SECTION 00 91 13.2 – ADDENDUM 2

- A. Project Name: Lincoln Quad Demolition and Site Restoration.
- B. Owner: Indiana State University.
- C. Owner Project Number: B0027341.
- D. Architect: arcDESIGN, PC.
- E. Architect Project Number: 19189.
- F. Date of Addendum: Friday, October 9, 2020

ALTERNATE GRADING & UTILITY PLAN

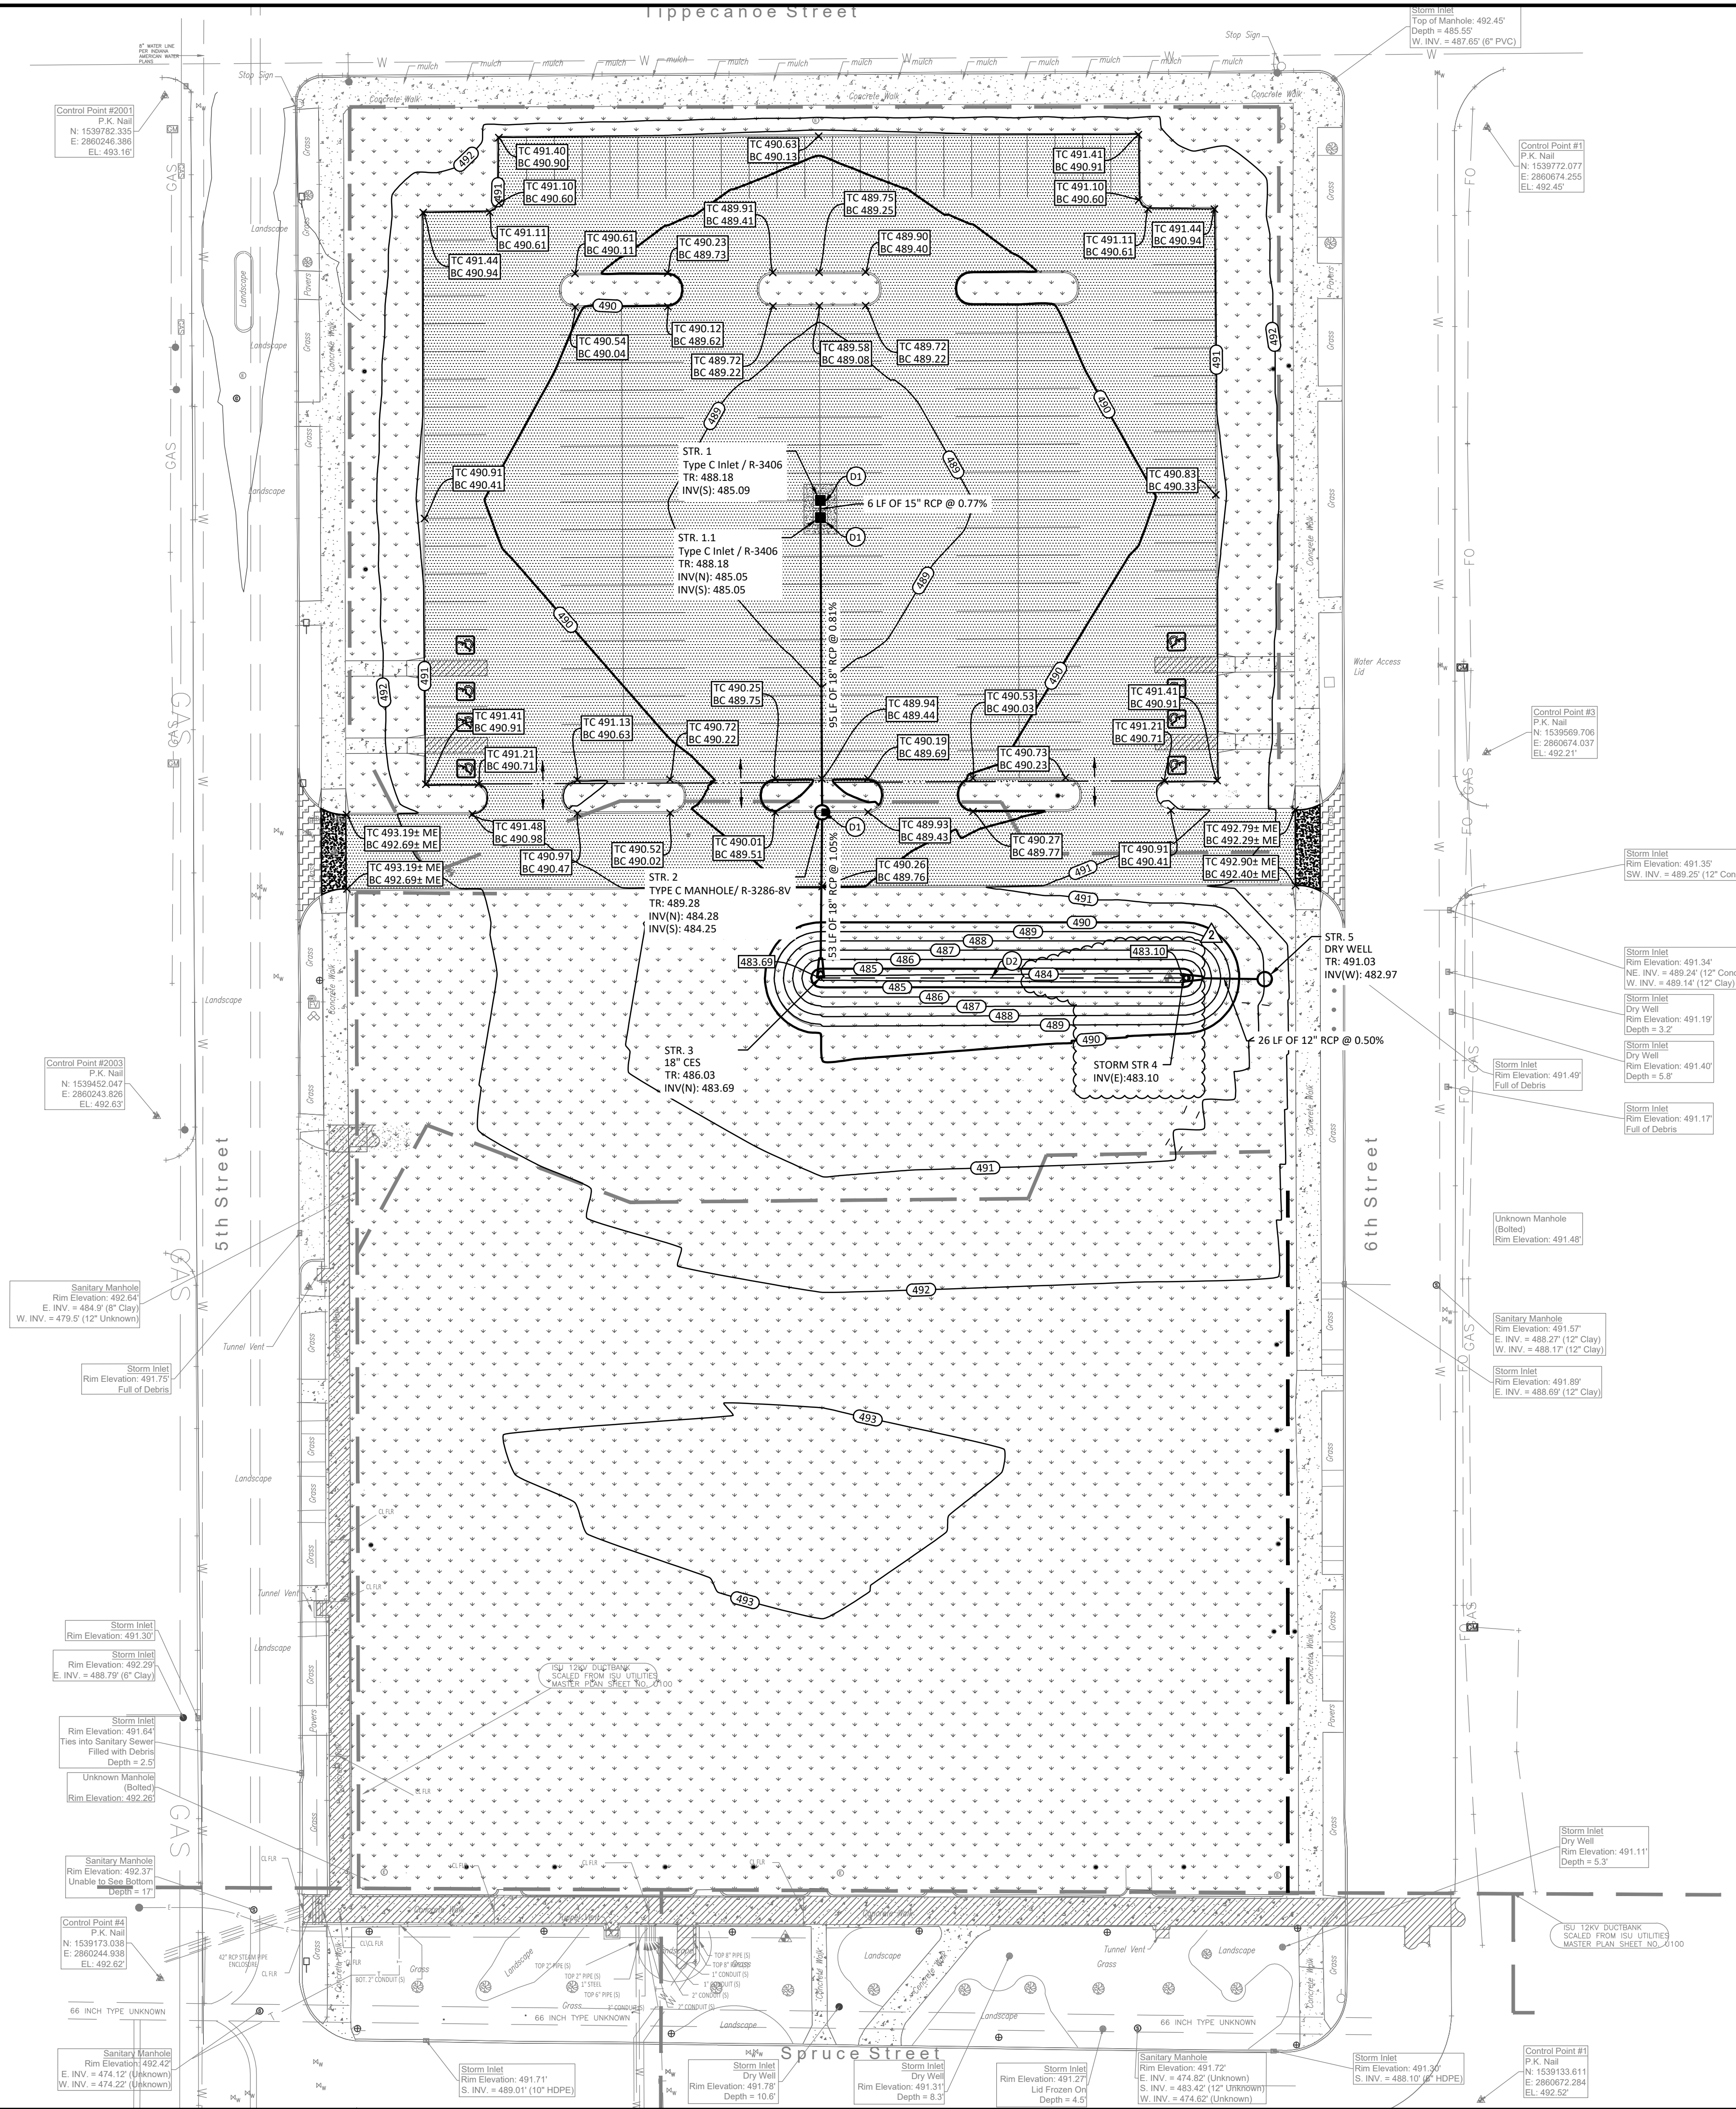
- A. Sheet C-300A – Alternate Grading and Utility Plan (reissued).
 - 1. Revise Drainage Not D2. To read “Underdrain per Detail-A, Sheet C-450”.
 - 2. Revise Storm Structure 4 to 12” RCP End Section.

- 3. Add contour label (484) to bottom of detention basin.
- B. Sheet C-450 – Utility Details (reissued).
 - 1. Remove Detail “Underground Stone storage Detention System – Detail A” in its entirety.

- D1. PAVEMENT UNDERDRAIN PER DETAIL TYP.
- D2. UNDERDRAIN PER DETAIL-A SHEET C-450

DRAWING TITLE
UTILITY DETAILS

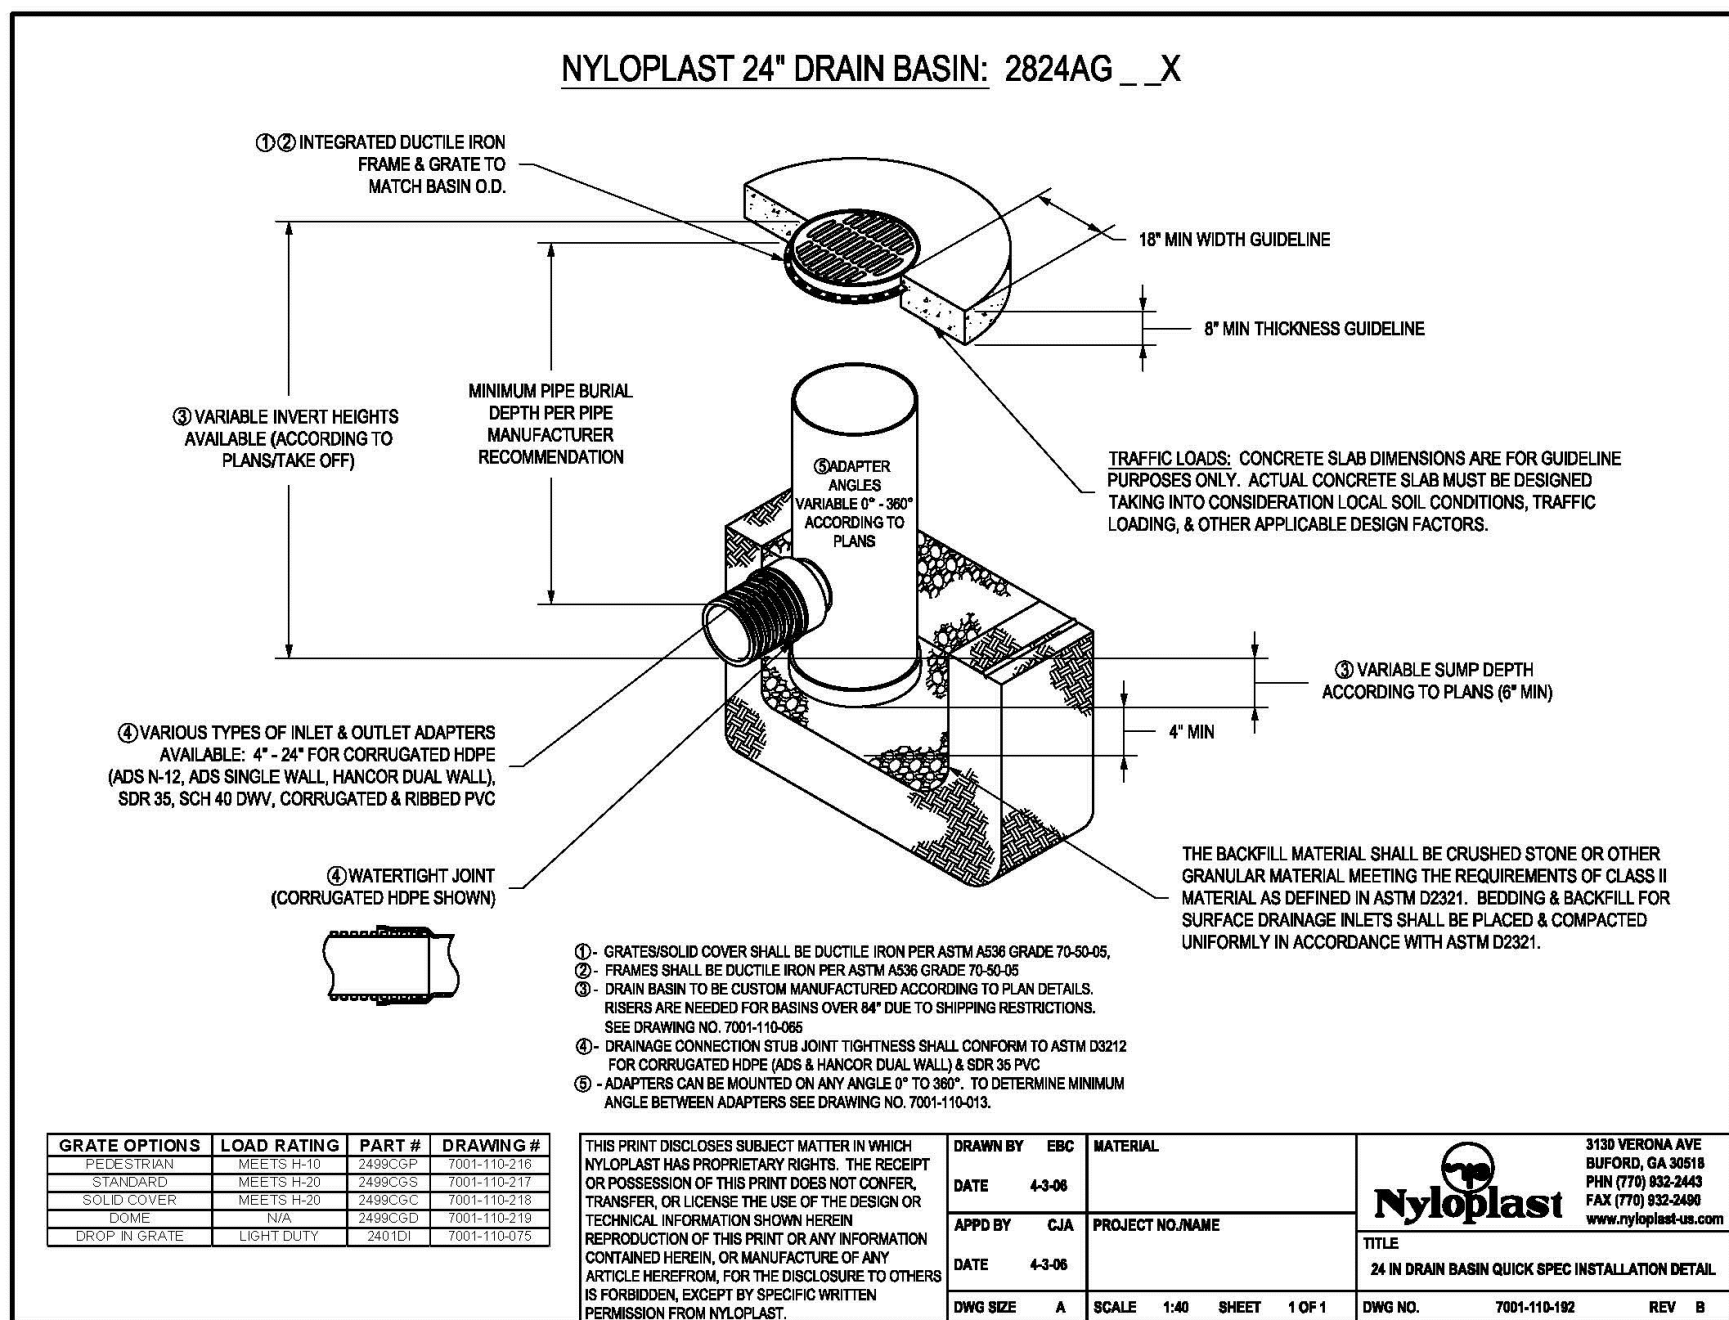
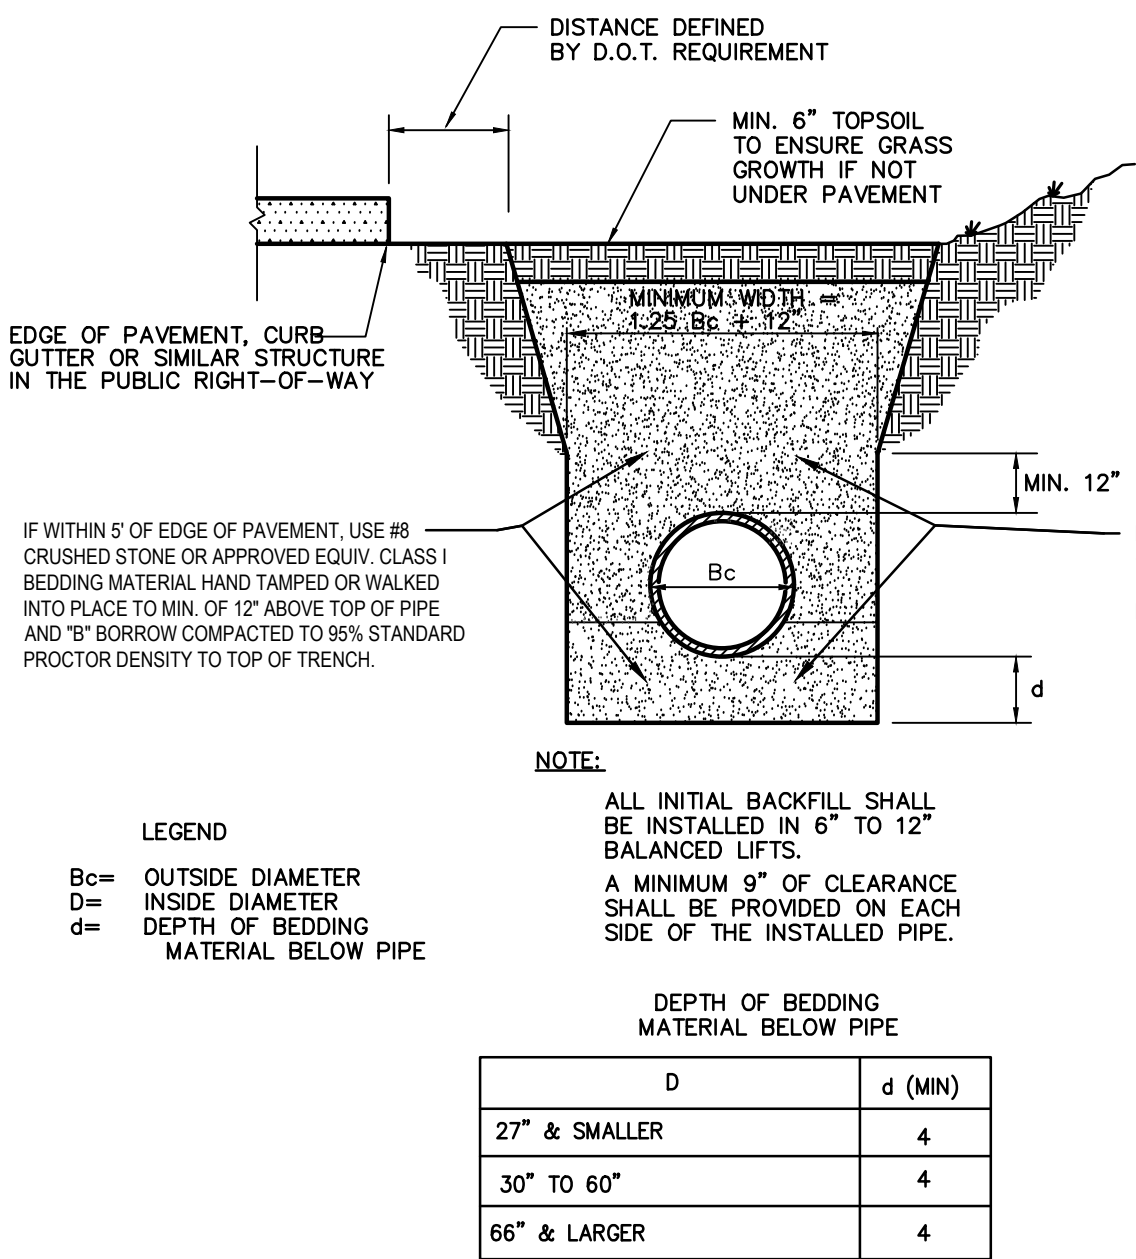
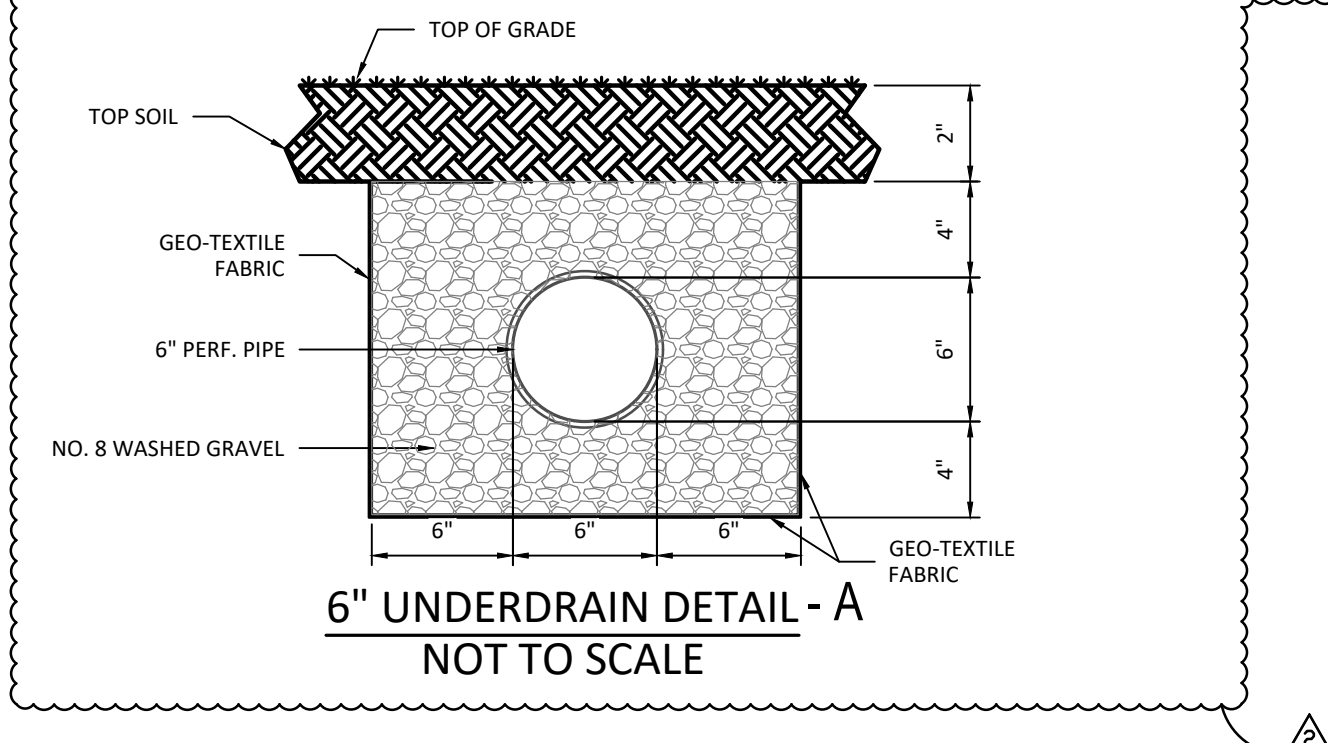
- 2. Revise Label (6” Underdrain Detail) to read “6” Underdrain Detail-A”
- C. Drawing No. MD-100 – Site and Tunnel Demolition - Mechanical (not reissued).
